30S-1 RF LINEAR AMPLIFIER

SERVICE BULLETIN NO 3

REDUCE EXCESSIVE ALC CONTROL

30S-1 SB 3 Modification, Components -- Wiring Locations
Figure 1

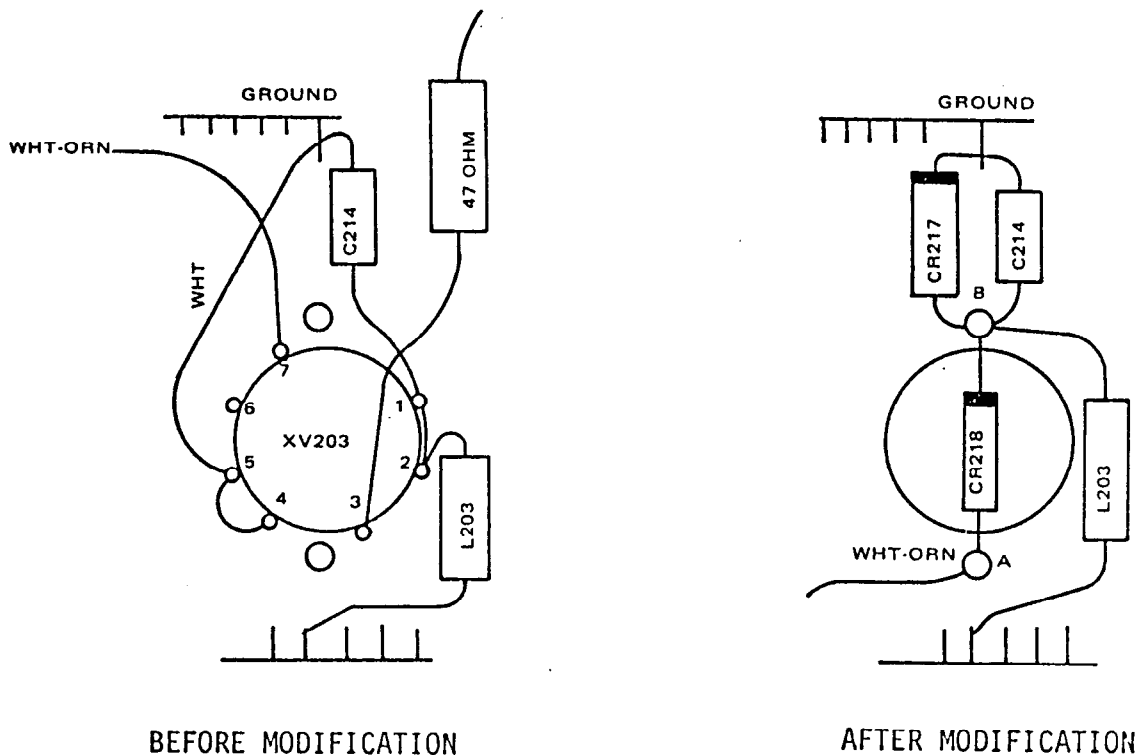
30S-1 units originally employed a 12AL5 dual-diode as the alc rectifier, V203. Some production runs of this tube exhibited high space-charge characteristics resulting in objectionable high standoff voltage on the alc line. The method recommended to ensure proper alc operating voltage is to substitute 1N457 silicon diodes for the tube.

NOTE: Refer to figure 1 for component and wiring locations in following steps.

3. Remove and discard white wire from XV203 pins 4 and 5 to terminal strip ground.
4. Remove securing hardware and lift socket XV203 out of the way.
5. Install two terminals A and B (306-0234-000) in removed XV203 socket mounting holes with screws (343-0285-000) and washers (373-8010-000).
6. Disconnect white-orange wire (from J202) at XV203-7 and reconnect it to terminal A.
7. Disconnect L203 lead from XV203-2 and reconnect to terminal B.
8. Disconnect C214 lead from XV203-1 and reconnect to terminal B. Discard XV203 that is now free of circuit.
9. Install 1N457 diode CR218 (353-0204-000) from terminal A to terminal B (banded end).
10. Install 1N457 diode CR217 (353-0204-000) from terminal B to terminal strip ground (banded end).

30S-1 SB 3 Modification, Schematic Diagram, Partial View
Figure 2

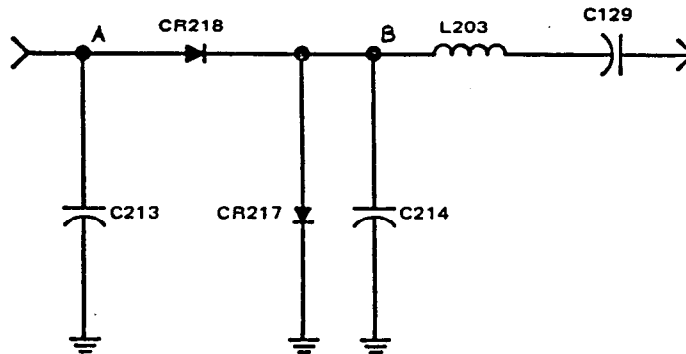
NOTE: Figure 2 is a schematic presentation of the modification.
